COMMITTEE OF THE WHOLE – AUGUST 31, 2010

SIGN VARIANCE APPLICATION

FILE NO: SV.10-021
OWNER: 1051727 ONTARIO LTD
LOCATION: 5289 HIGHWAY 7
PART OF LOTS 5 – 9, CONCESSION 8
REGISTERED PLAN 3762
WARD 2

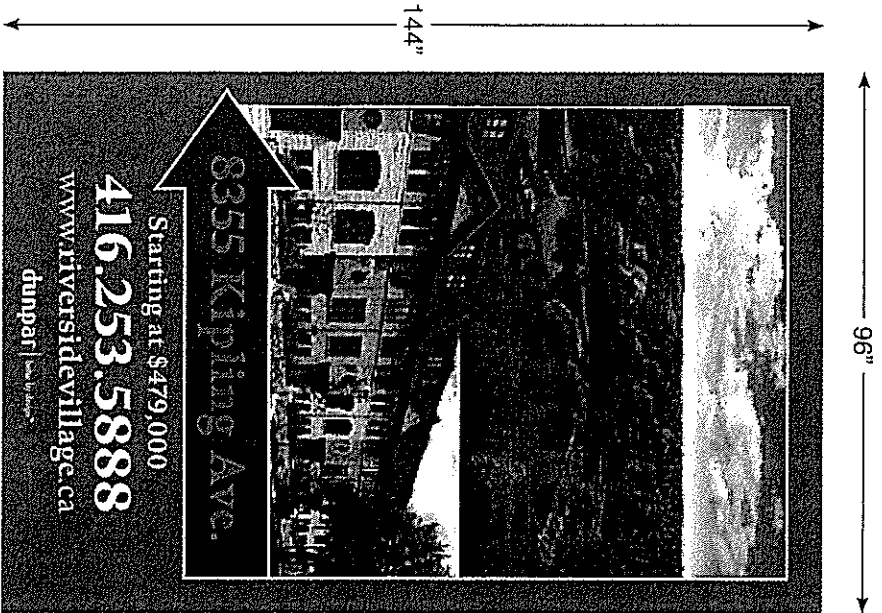
The applicant is proposing to install a 8.9 sqm. (96 sqft) 3rd Party Development sign on the subject property as shown on the attached drawings. The sign is proposed to be located on the south side of Highway 7 east of Kipling whereas the housing development is located 1.6 km north on east side of Kipling Avenue.

Crezone A-Frame Sign
Quantity 2

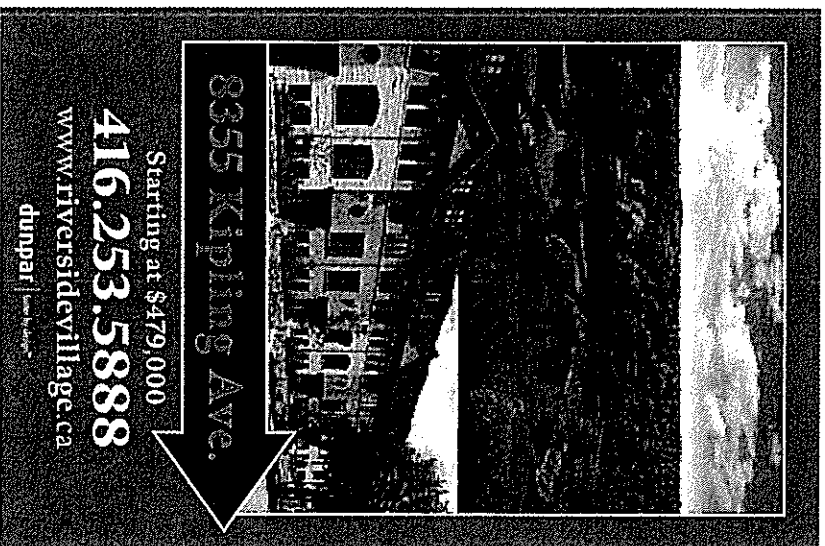
The City's Sign By-Law does not permit this type of 3rd party advertising. Members of the Sign Variance Committee are of the opinion that other than the permitted builders "A"- Frame Signs, all other development signs should be located on the lands being developed.

Members of the Sign Variance Committee do not support the application.

That Sign Variance Application SV.10-021, 1051727 Ontario Ltd., be REFUSED.
